Refer to: HSA-B85

In his May 21 letter to Mr. Richard Powers of my staff, Mr. Don Johnson requested the Federal Highway Administration's (FHWA) acceptance of the King Recycled Composite guardrail offset block (King Block) for use with strong post, metal beam guardrail installations on the National Highway System (NHS).

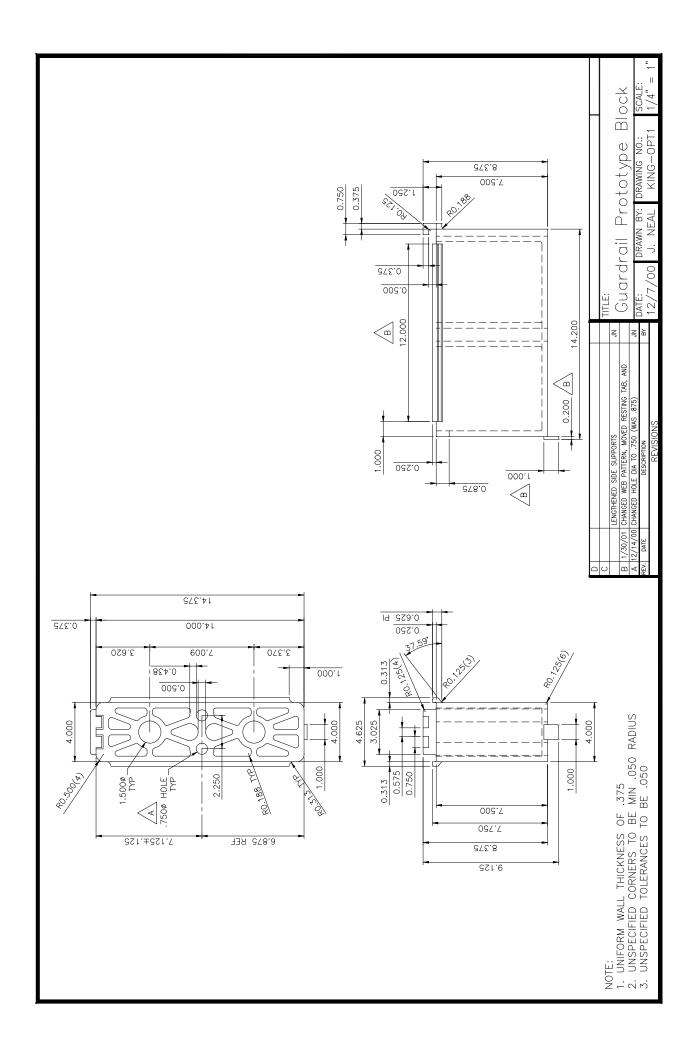
The King Block is an injection-molded product, consisting of approximately 67 percent high density polyethylene (HPDE), 30 percent ground rubber, 2 percent Black concentrate, and ½ percent blowing agent. The external dimensions of the King Block, which has a honeycombed interior, are 105 mm x 185 mm x 355 mm (4.0 inches x 7.3 inches x 14.0 inches). The post face of the block includes a protrusion at the top so the blocks can be hung from the steel posts during the installation of the w-beam rail element. The rail face of the block has a tab at the bottom so the rail can be supported during installation. These and other details are shown in Enclosure 1.

Since the King Block is both narrower and deeper than other offset blocks that have been accepted for use on the NHS based on pendulum and/or full-scale tests, my staff recommended a full scale crash test in addition to your original pendulum testing to confirm satisfactory impact performance when this block is used with the steel post w-beam guardrail. The results of your subsequent test were documented in the Texas Transportation Institute's May 2001 test report, prepared by Alberson, Menges, and Schoeneman, and entitled "NCHRP Report 350 Test 3-11 of the Strong Post W-Beam Guardrail with Trinity Composite Blockout." This test showed that the 2000-kg pickup truck impacting at 101.4 km/h (63 mph) and 23.8 degrees was contained and redirected with very moderate roll, pitch and yaw angles. Maximum occupant impact velocity and ridedown accelerations were 9.3 m/s (30.5 fps) and 4.5 g's, respectively. Maximum dynamic deflection of the barrier was reported to be only 0.9 m (2.9 feet).

Based on our review of the information you provided, the King Block is considered acceptable for use on the NHS with a strong steel post guardrail when molded to the same dimensions and composed of the same materials as the tested blocks. As with all other recycled blocks we have reviewed, this FHWA acceptance is based solely on the reported impact behavior of your product and does not address the long-term performance or durability of this product. Since the
